*Appraisal of* Planning Application Ref No 2022/5320/P

Camden Council

the former Mansfield Bowling Club

Planix.UK Planning Consultants Ltd

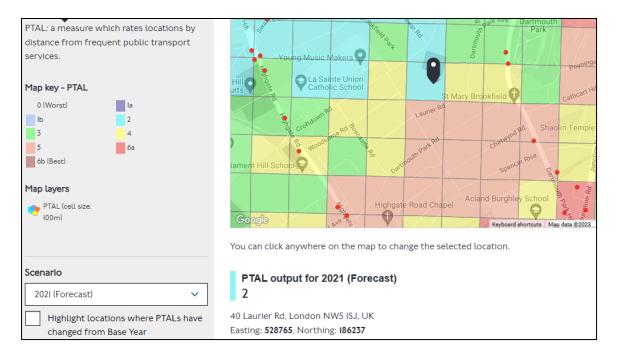
- 10. As the images above show, whilst the proposed residential re-development consented in 2017 would have responded relatively positively to the characteristics of the surrounding residential buildings (as concluded by the appeal inspector), in contrast the design of the current application, including its scale, bulking and form, would be significantly uncharacteristic of the area.

- 11. Similarly, whilst the built form of the 2017 consented scheme would have assisted in allowing its bulk to appear reduced, the design of the current application emphasises its increased bulk to the detriment of the character of the area.

- 12. The Council's Conservation Area Appraisal and Management Statement highlights the semirural character of the area around the application site.
- 13. The increased massing and bulk of the proposed development would appear to grate against this character significantly, and would thus cause at least less than substantial and possibly substantial harm to the heritage significance of the Dartmouth Park Conservation Area. Either way it would be far from meeting the preserving let alone the enhancing tests set by Local Plan Policy D2 section e.

- 14. Also, given the juxtapositions of buildings of significantly different scale and massing and the lack of any gradual transition, the proposal appears to be contrary to Policy DC3 of the neighbourhood development plan.
